rev 'A' - 07.05.08 - Building Control Amendments

Site:
Mr & Mrs L. Allen
78 North Road
Gedney Hill
PE12 0NS

Drawing Title
**Building Control
Specification**

Drawing No:
1495 - 05 'A'

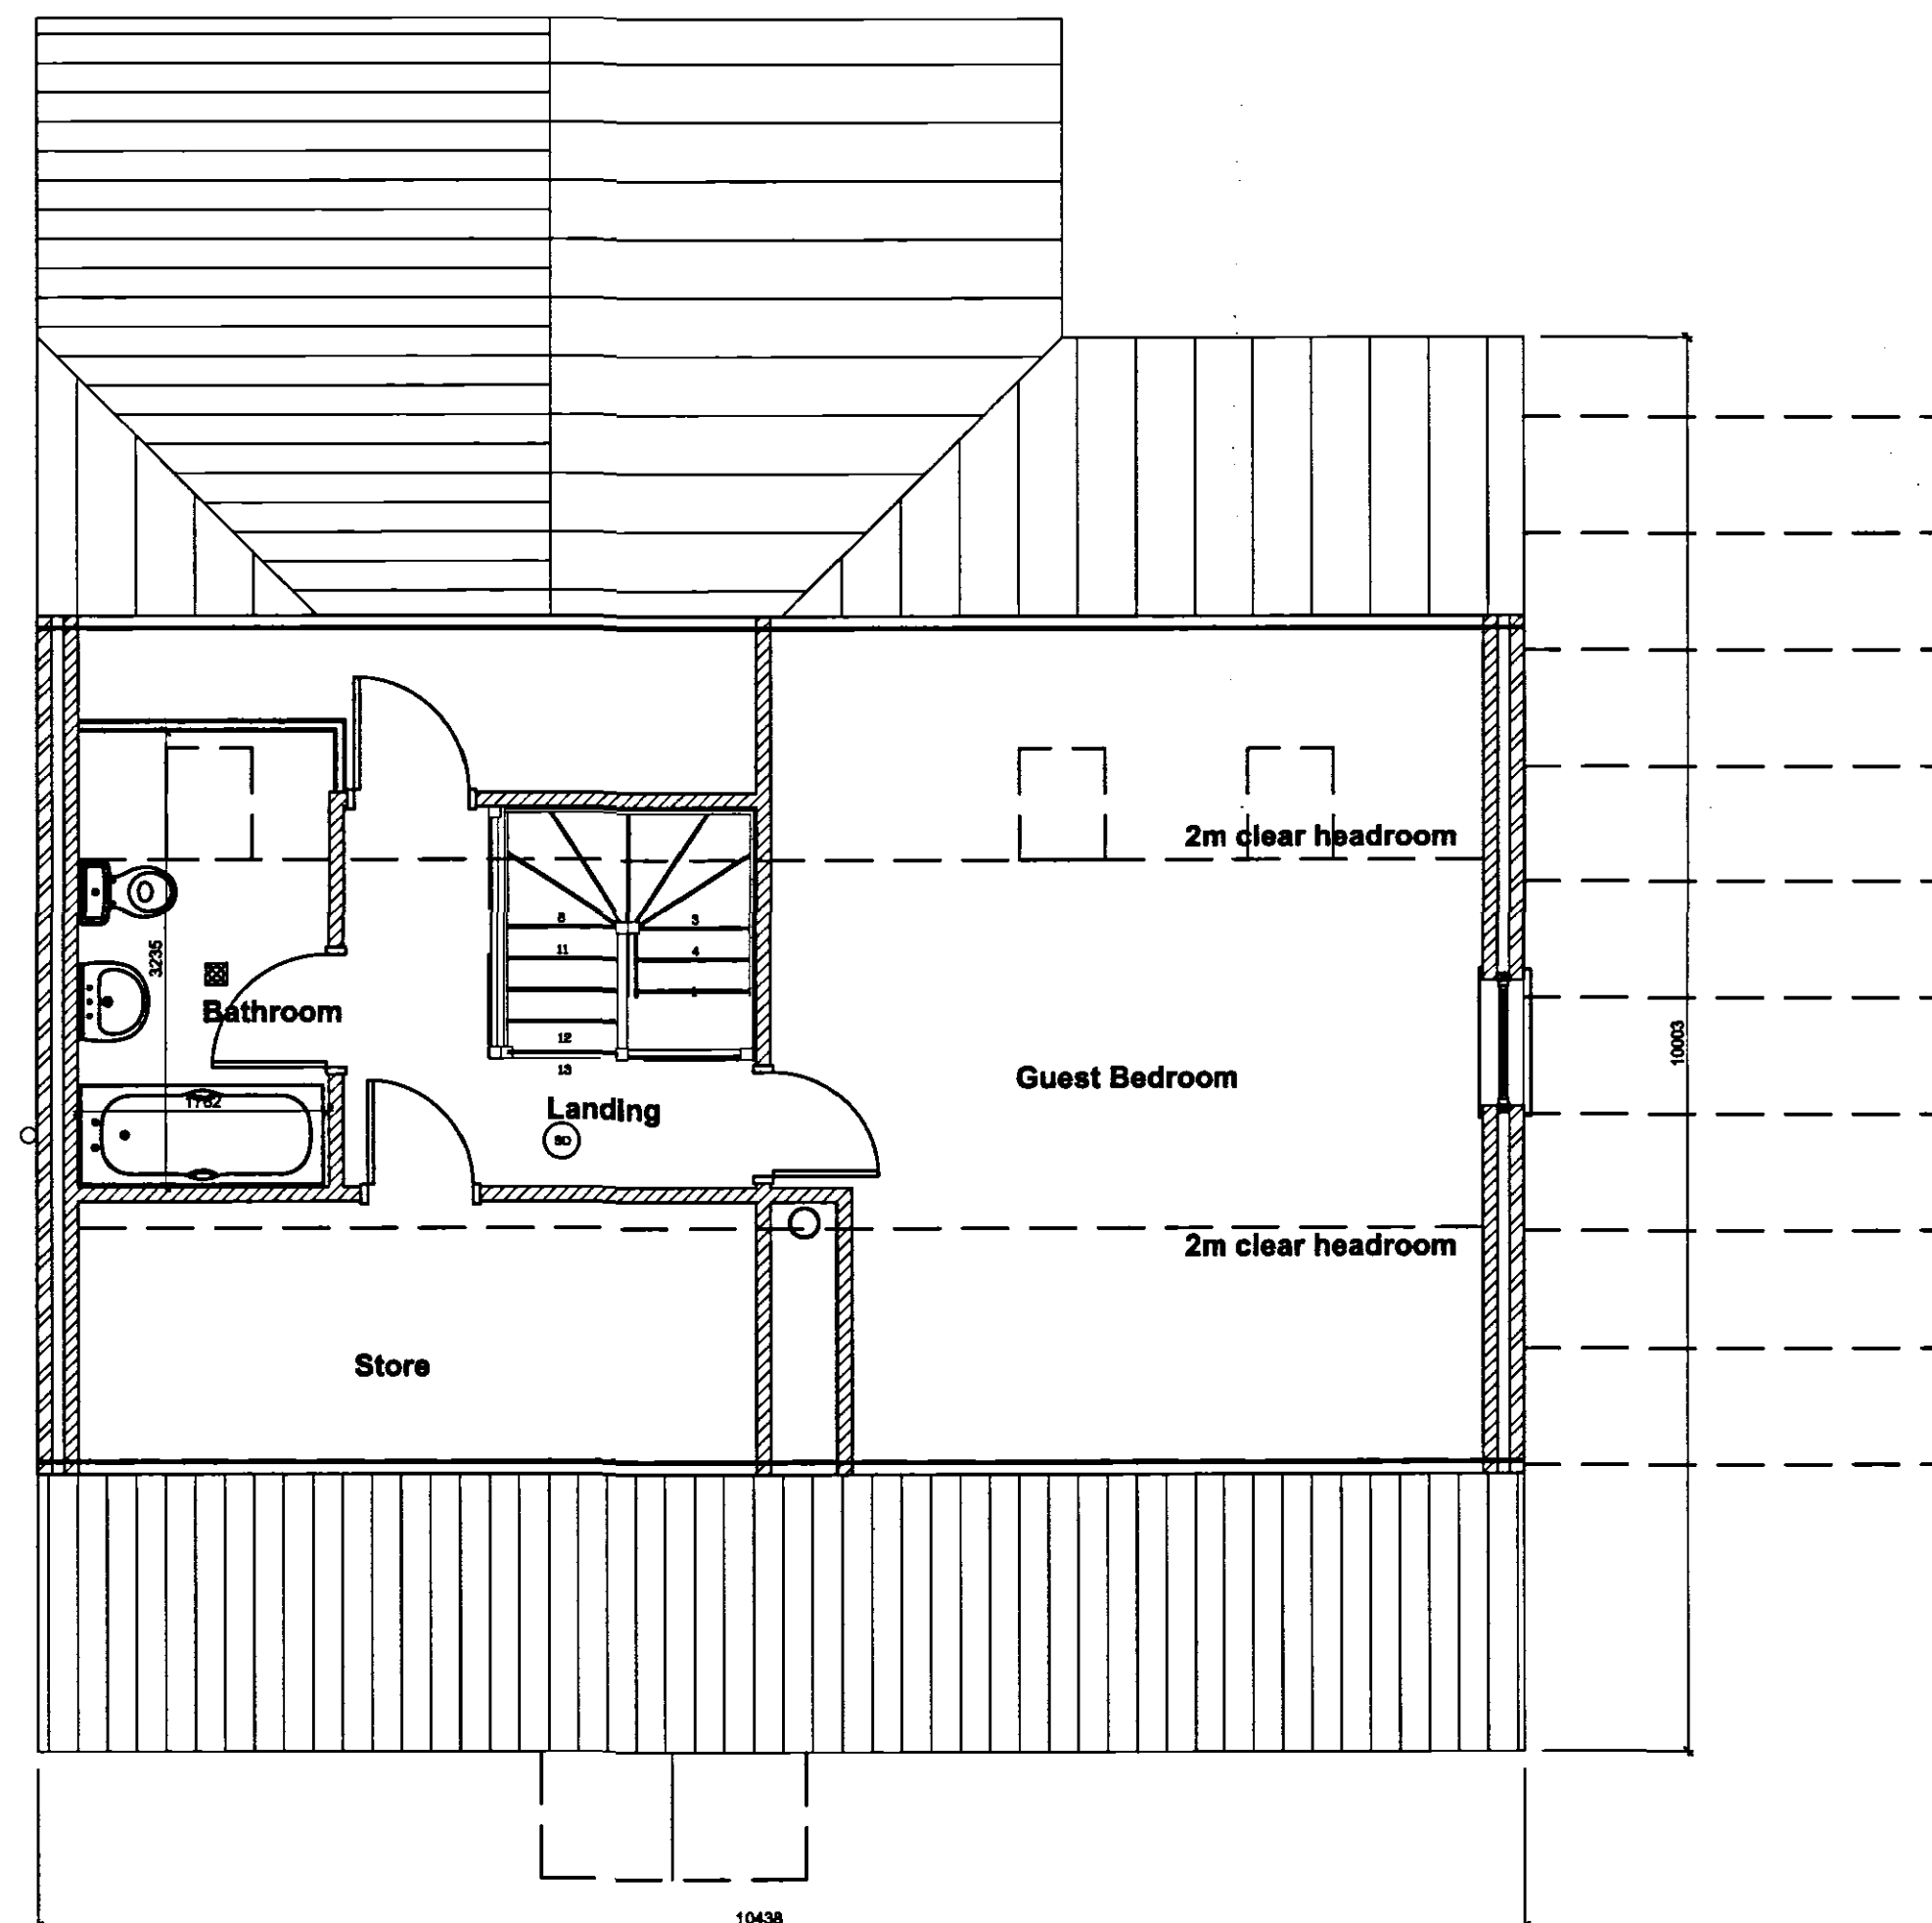
CONTRACTOR PLEASE NOTE:
The following amendments are to be made to the standard specification notes in order to conform to the SAP Calculations:

- Accredited Details Applicable are 3.01 Pitched Roof Eaves, 3.02 Pitched Roof Gable, 3.10 Windows and Doors Head, 3.12 Cills, 3.14 Ground Floor Bearing Slab & 3.22 Intermediate Timber floor.
- Fireplace is to have a Closed Wood Bumer
- 100mm Celotex between Rafters for Sloped Insulation
- Wall Insulation to be Crown Dritherm Cavity Slab 32
- Heating to have Two Zone Controlled Heating System
